# EASTERN SAN JOAQUIN GROUNDWATER AUTHORITY

### AGENDA

**Subject: Eastern San Joaquin Subbasin (No. 5-022.01)—Response to April 17, 2026 Additional Information Request Regarding the 2025 Periodic Review**

## TECHNICAL MEMORANDUM

**Figure 1: Inventory of Domestic Wells with Identified Impact Zones**

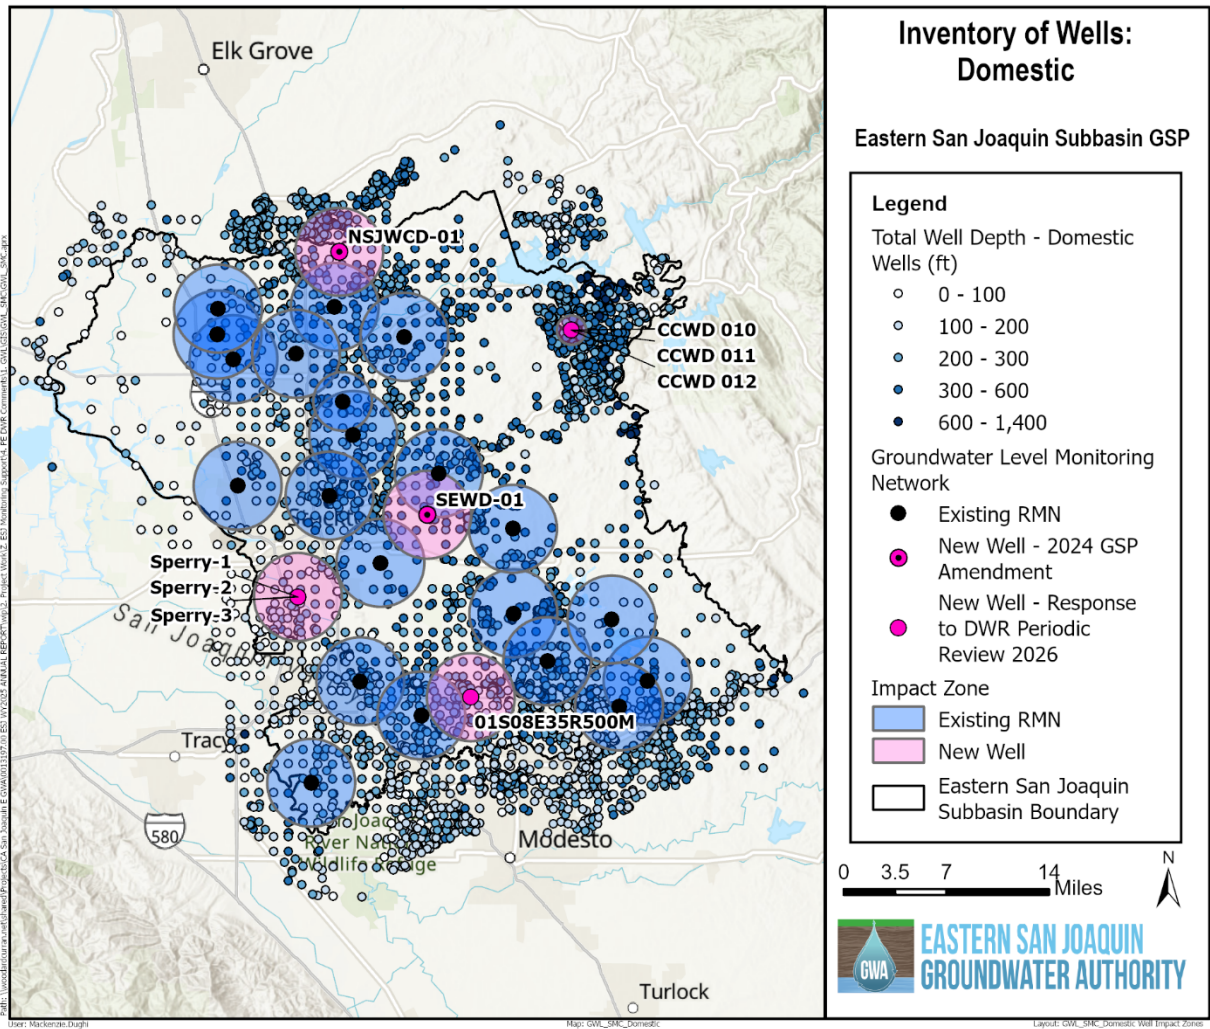
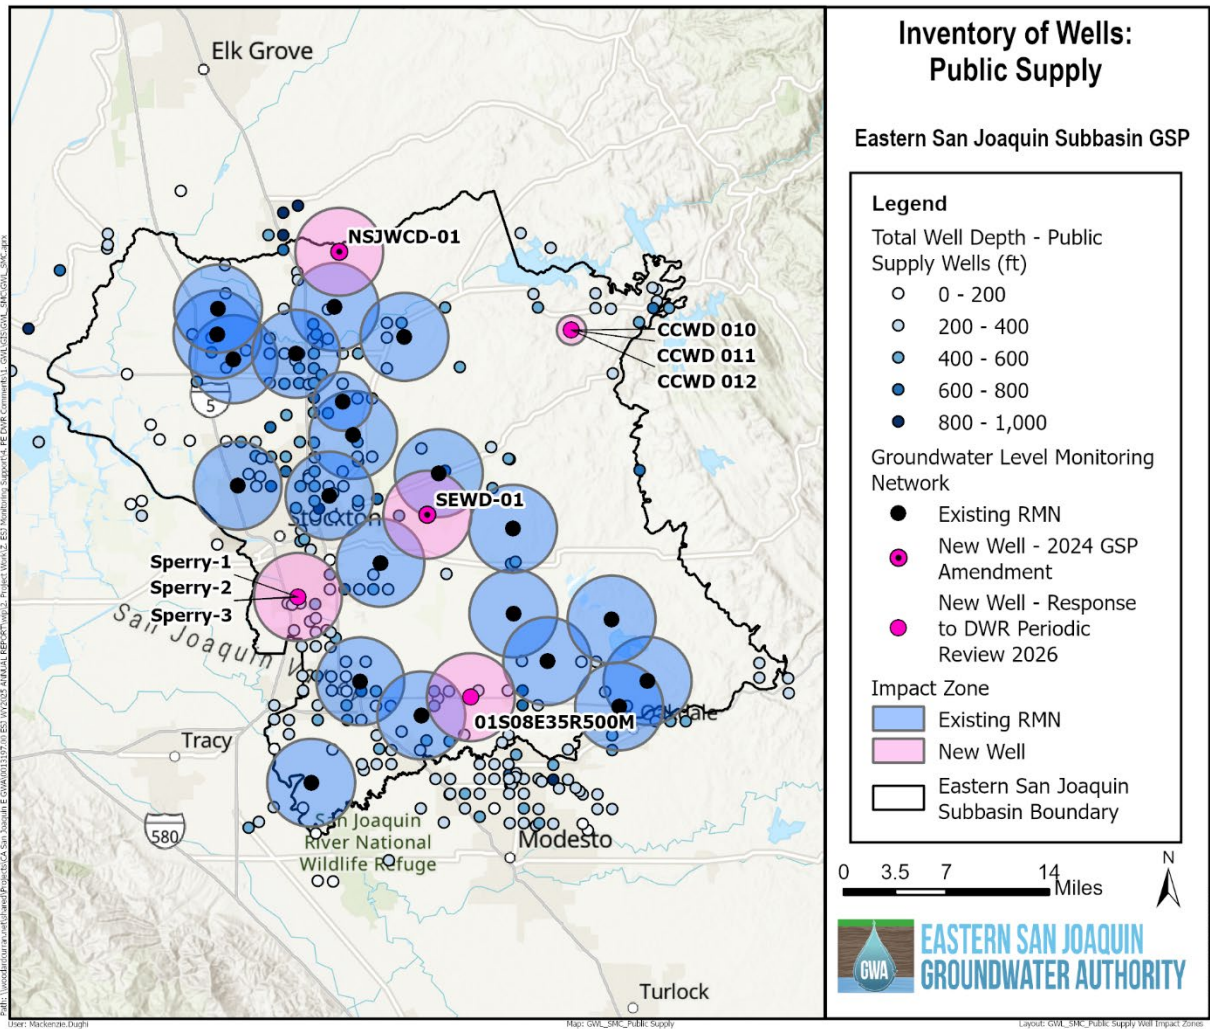
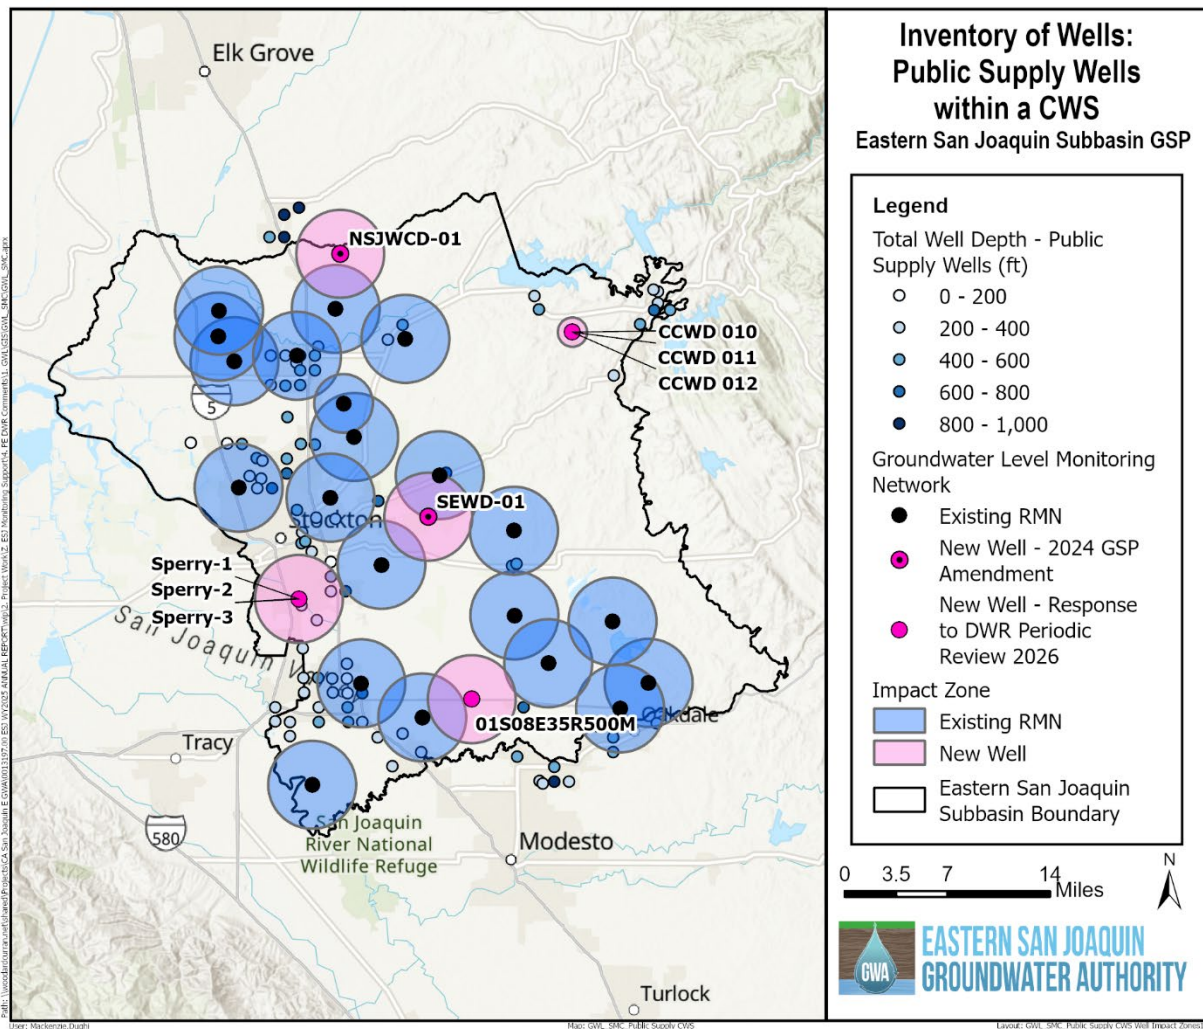
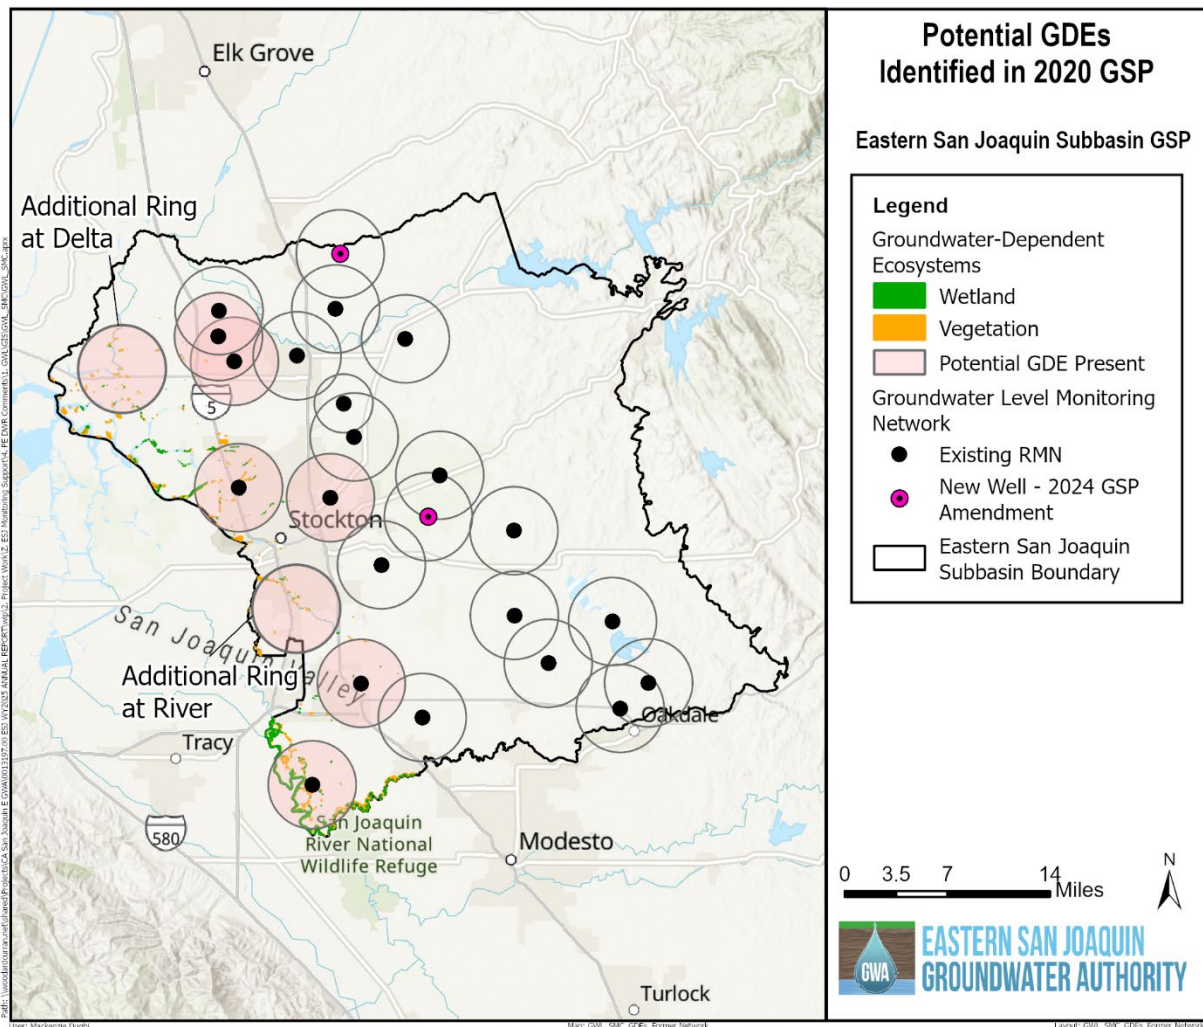
*"Provide an explanation for how the well impact analysis considers (or is representative) of the areas outside of the 3-mile "Impact Zone" radii."*

Beyond the impacts around the RMN wells, as described in Section 5 above, the 2024 GSP Amendment also looked at two additional "hypothetical" impact zones in sensitive areas: one along the San Joaquin River and one in the Sacramento-San Joaquin River Delta (Delta). Results from the hypothetical radii analysis indicate that potential impacts remain limited even under UR definitions that are more protective than the current UR definition. Figure 4 shows where these two hypothetical impact zones were located.

The 2024 GSP Amendment impact analysis included 4,855 domestic wells, 165 public supply wells, and 58 public supply wells within CWSs. DWR noted that this represents less than 50% of the total domestic wells within the Subbasin. In response to DWR's comments, the GWA has expanded the RMN by adding new representative monitoring wells in areas identified by DWR as having a high density of domestic wells. Updated impact analyses were completed for each newly added well with SMCs developed as part of this TM. Expanding the impact analyses in this manner increases the spatial coverage of the evaluation while maintaining the same analytical methodology described in the 2024 GSP Amendment. Details on these newly added wells and the corresponding impact analysis results are included in the following sections.

**Figure 7: Mapping of Potential Groundwater Dependent Ecosystems and Expanded Impact Zones**

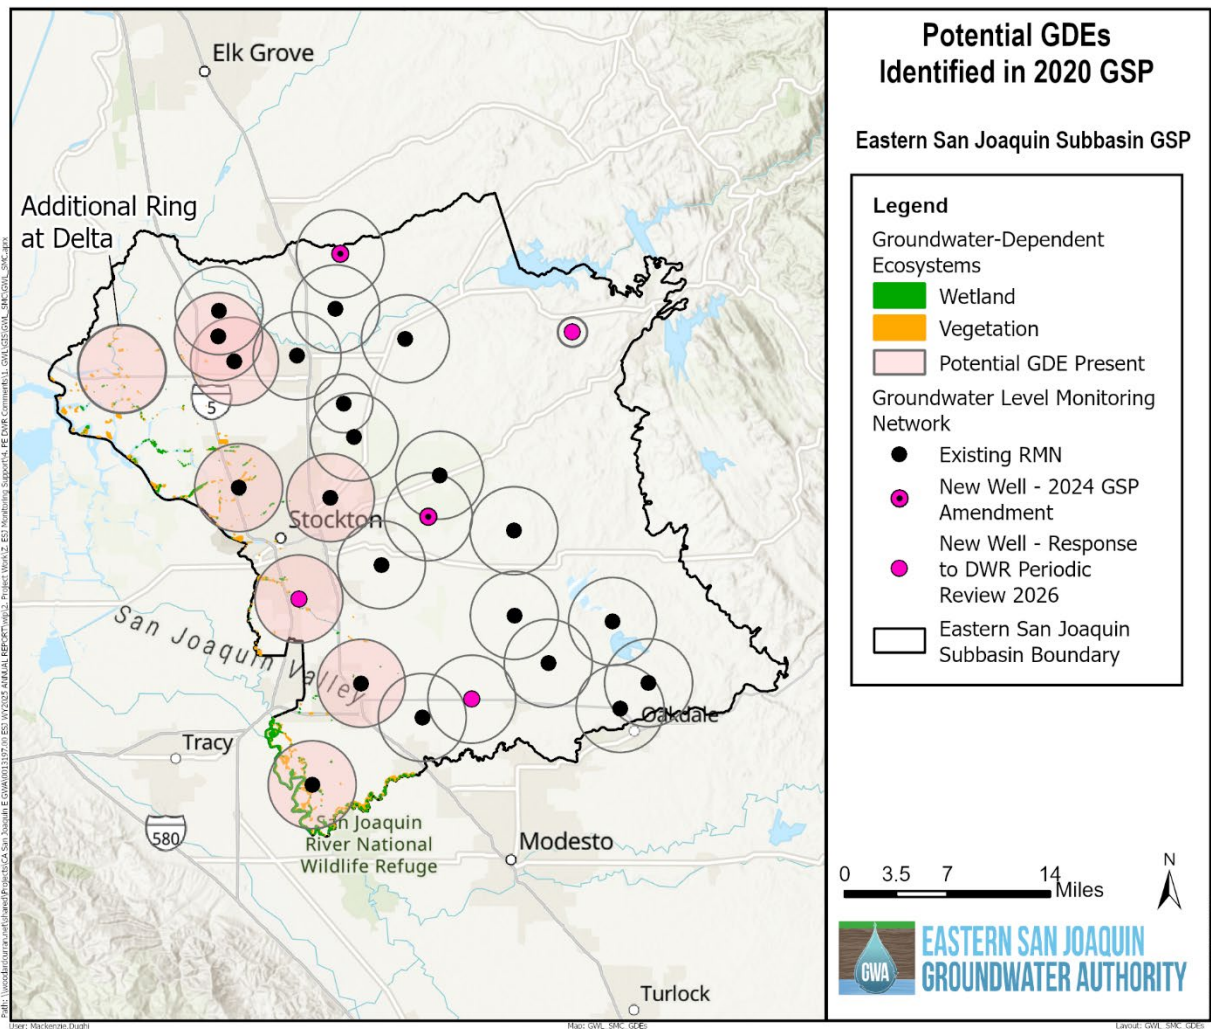
*"Provide further justification for the usage of groundwater level RMN 3-mile impact zones for evaluation of GDE impacts when only four of those zones overlap with potential GDEs."*

In the expanded analysis, 41 additional potential GDEs are included in the impact zone of the newly added Sperry wells. Potential GDEs overlap eight impact zones, seven of which are at RMN well locations, as shown in **Figure 7**. Only four of those zones indicate possible impacts to GDEs under UR conditions (seven or eight representative monitoring wells with groundwater levels at their respective MTs). The potential impacts in those four zones are summarized in **Table 8**.

It is important to note that this desktop analysis serves only as an initial step toward identifying where potential GDEs might be at a higher risk of being impacted. The analysis is meant to provide the Subbasin GSAs with a starting point as they prioritize field verification activities. Once the location of GDEs within the Subbasin are confirmed, a more comprehensive impacts analysis of undesirable result conditions can be prepared. This could be included in the next Periodic Evaluation, if DWR agrees that is an appropriate timeline.

**Figure 8: Status of Most Recent Water Level Measurement in Comparison to 2025 Interim Milestones**

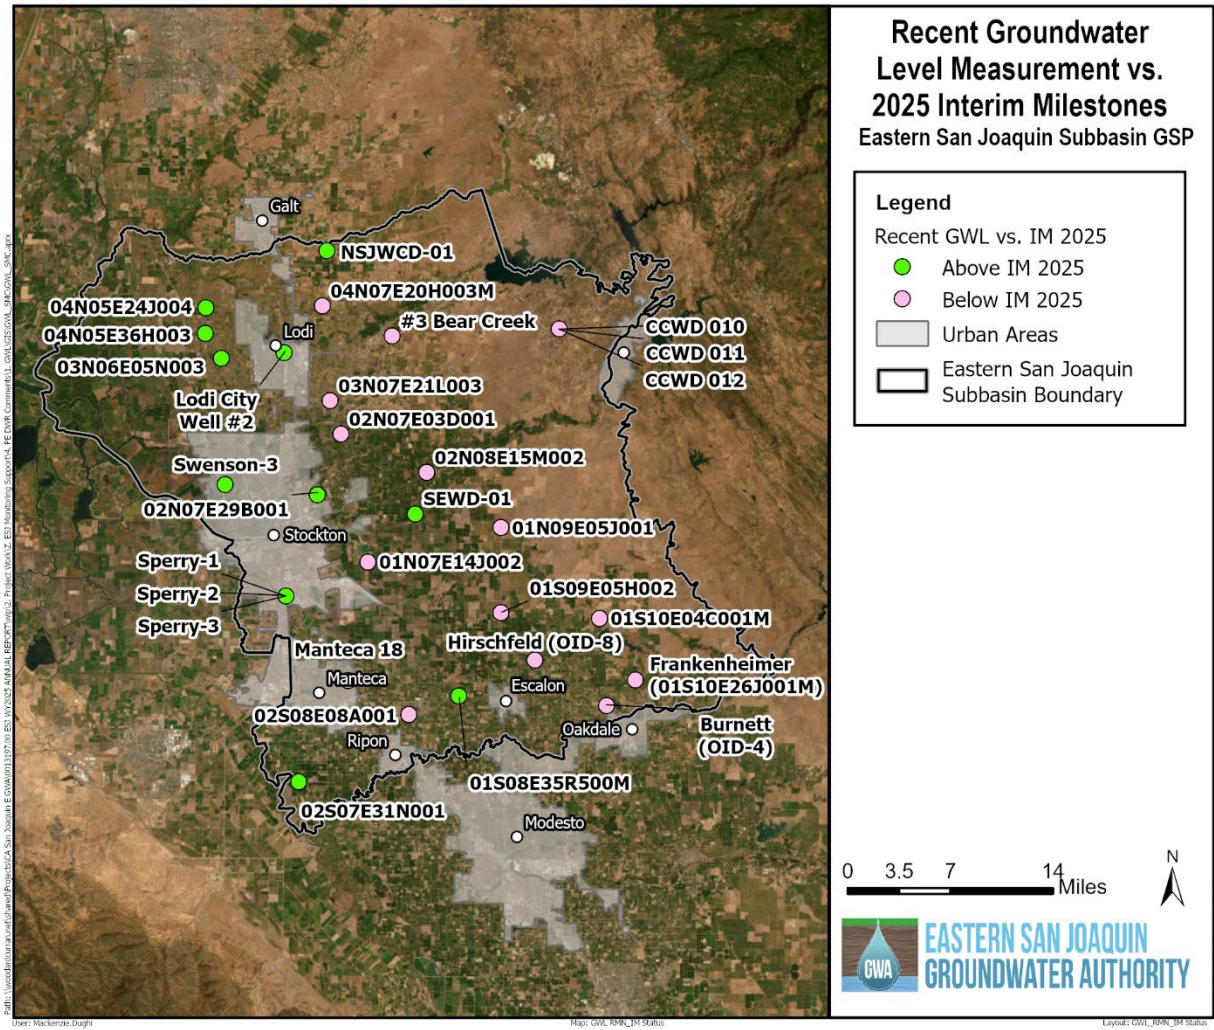
*"Please clarify whether the Subbasin has been meeting its interim milestones."*

**Table 9** compares the most recent groundwater level measurements at each representative monitoring well to their applicable 2025 IM. Of the 30 representative monitoring wells evaluated, 14 are currently above their 2025 IM, while 16 are below. Of the 16 wells currently below their 2025 IM, 13 are located in the eastern and central portions of the Subbasin. This area is predominantly agricultural, and groundwater pumping to meet irrigation demand is a primary driver of groundwater level conditions in this portion of the Subbasin (**Figure 8**). Wells in the western portion of the Subbasin are predominantly above their 2025 IMs.

IMs are planning targets established to demonstrate progress toward the MO; therefore, groundwater levels below the 2025 IM do not necessarily indicate unsustainable groundwater conditions but rather that progress toward the IMs should be considered together with long-term groundwater level trends and the relationship of groundwater levels to the established MTs.
